Date Created : 2009/04/03
Date Issued On : 2009/04/14
PCN# : Q2091404

DESIGN/PROCESS CHANGE NOTIFICATION -- FINAL

Change Type Description: Assembly Process, Lead Finish Composition, Package Change (Lead Frame), Package External Dimension

Description of Change: 6. Dimensional Outline

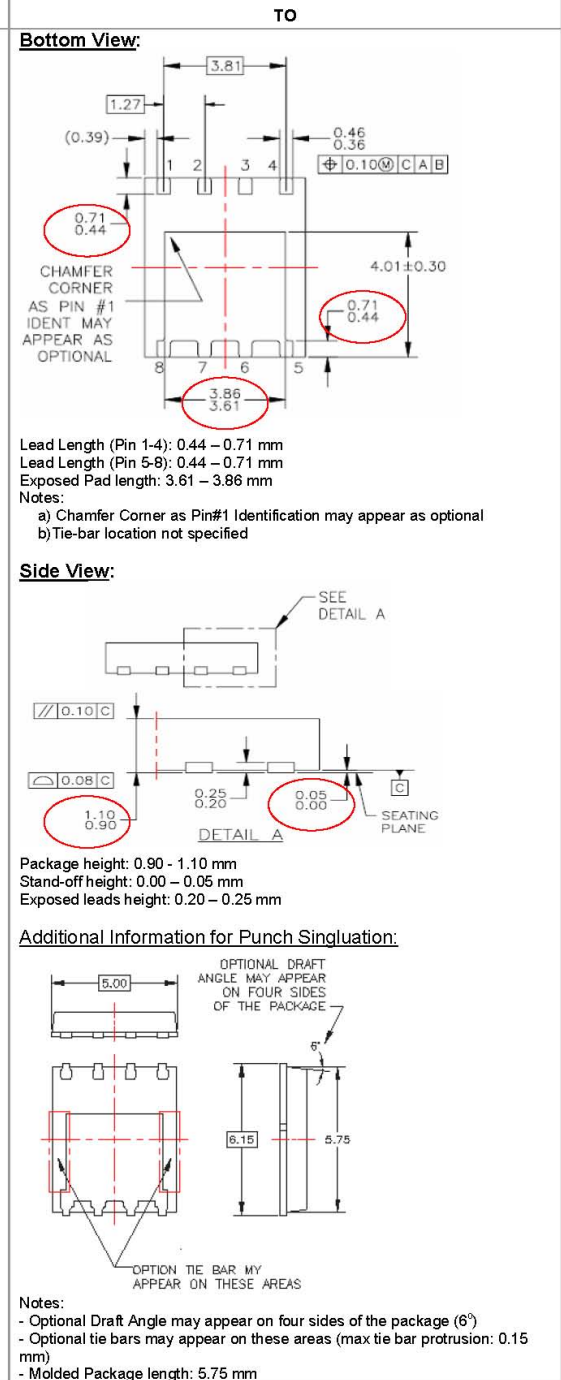
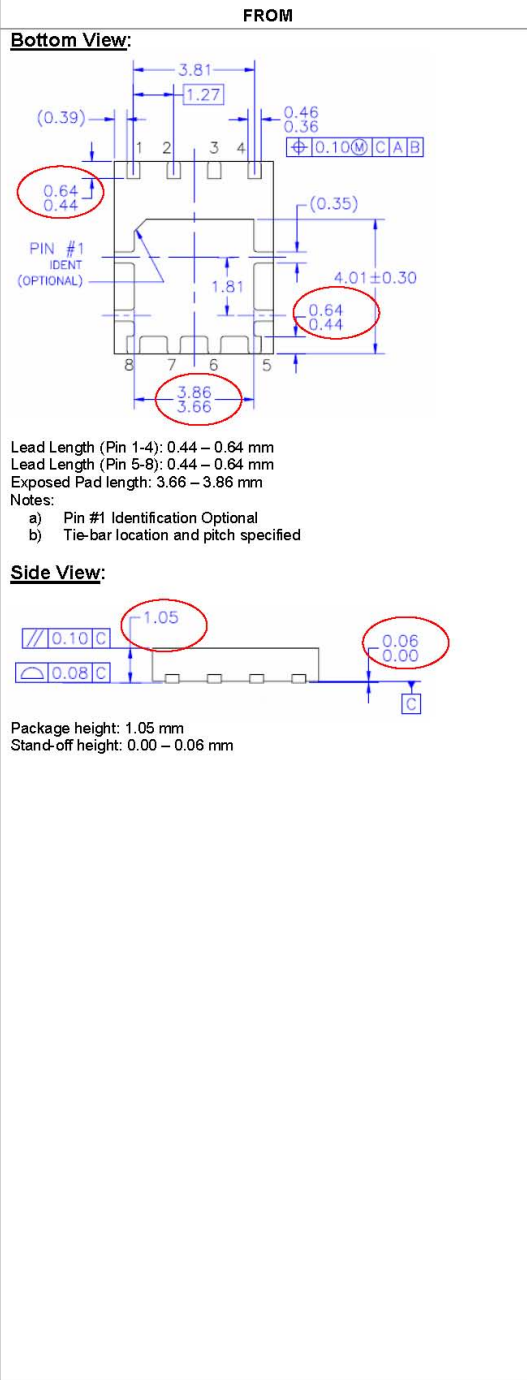
Description of Change (From): Selected MOSFET products assembled in Power 56 package, in which the current Die Attach Pad & Leadpost plating is NiPdAu; current Gate Leadpost Plating is NiPdAu; current Gate Interconnect is 5mil Al wire; current Singulation Method is Saw-Singulation and current Plating Finish is NiPdAu. To view "From/To" Dimensional Outline, please refer to the attached table "Dimensional Outline."

Description of Change (To): The alternate Die Attach Pad & Leadpost plating will be Bare Cu; alternate Gate Leadpost Plating will be Ag; alternate Gate Interconnect will be 2mil Cu wire; alternate Singulation Method will be Punch-singulation and the alternate Plating Finish will be Pure Sn.

Description of Change:	FROM:	TO:
1. Die Attach Pad & Source Leadpost plating	NiPdAu	Bare Cu
2. Gate Leadpost Plating	NiPdAu	Ag
3. Gate Interconnect	5mil Al wire	2mil Cu wire
4. Singulation Method	Saw Singulation	Punch Singulation
5. Plating Finish	NiPdAu	Pure Sn

Reason for Change : In addition to the current qualified Saw-singulated Power 56 package, Fairchild Semiconductor intends to qualify the Punch-singulated Power 56 to support volume ramp. There will be no change to the part number as the Punch and Saw-singulated Power 56 share common land pattern dimensions and are interchangeable
